SERVICE BULLETIN	
Product:	AW1-12 French Door Refrigerators
Bulletin Date:	4/10/2015
Bulletin Number:	ASC20150410001
Models Effected:	RF260BEAE, RF261BEAE, RF263BEAE, RF263TEAE All Colors

SUBJECT:

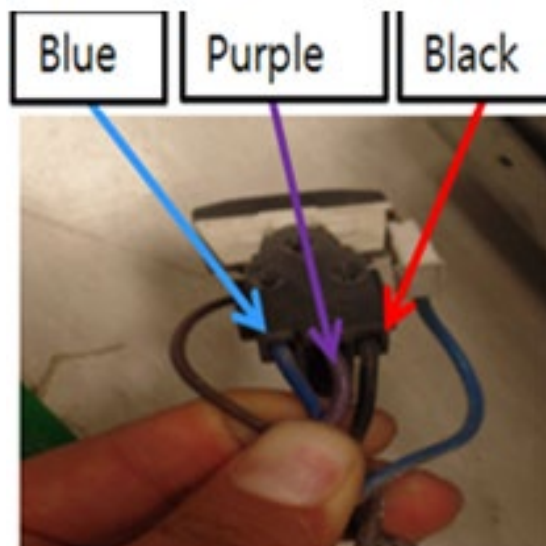
The compressor harness assembly is in the wrong position at the compressor. The harness at the compressor connector is reversed. See the illustrations below of a bad wire harness and a correct wire harness.

Example of a Bad Harness

Example of a Proper Harness

The overall result is that this causes a reverse rotation of the compressor, eventually producing a locked shaft.

1. - Replace the compressor.
2. - Replace the Wire harness – Comp.
Part number: [DA39-00154L](#)
